*City of Rancho Palos Verdes*  
**Rancho Palos Verdes ADA Assessment**  
**Facility Report with Photos**

**Facility ID: # 07 - Fred Hesse Jr. Community Park (Upper Part)**

**Location:** Meeting Room  
**Photo #** 14

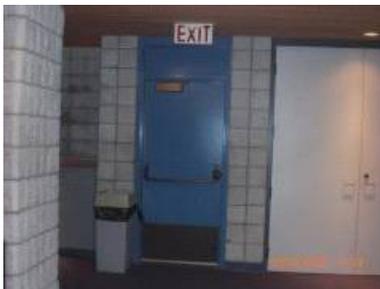
<b>Corrective Action</b>
079 - Doors - Miscellaneous - See Additional Comments
<b>Additional Comments:</b> Remove door stop.

**Location:** Meeting Room  
**Photo #** 14

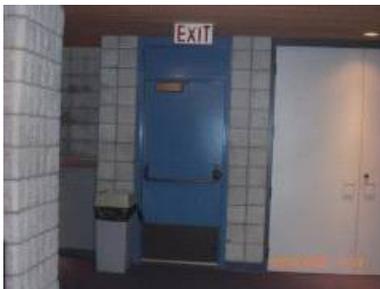
Corrective Action
072D - Replace Hardware with Panic Device - Replace door hardware with panic device.
Additional Comments:

Location: Meeting Room      Photo # 21

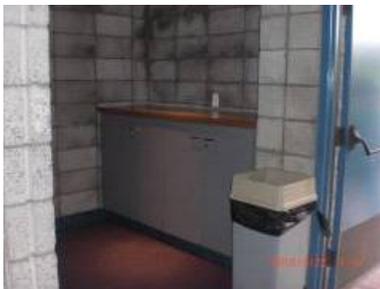
<b>Field Condition</b>									
14.28 - Fixed/Built-in Seating, Tables or Counters - At fixed or built-in seating, tables, or counters in public or common employee areas, less than 5% of the provided seating spaces are wheelchair accessible and have a 30" by 48" clear space which overlaps an accessible route of travel. (Wheelchair accessible seating spaces are between 28" - 34" high and with knee space measuring at least 27" high, 30" wide, and 19" deep.) (These elements include study carrels and student laboratory stations.)

<b>Corrective Action</b>
473B - Counter Modifications - Height - Modify counter to provide accessible countertop height.
Additional Comments:

Location: Park Area Photo # 230

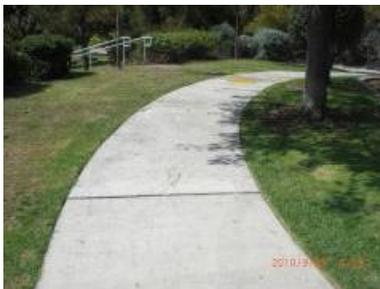
<b>Field Condition</b>									
03B.13 - > 1/2" Changes in Level - Curb ramps, ramps, or elevators are not used for changes in level greater than 1/2 inch. (Lifts may only be used in certain limited situations.) Existing Condition: 3/4" high.
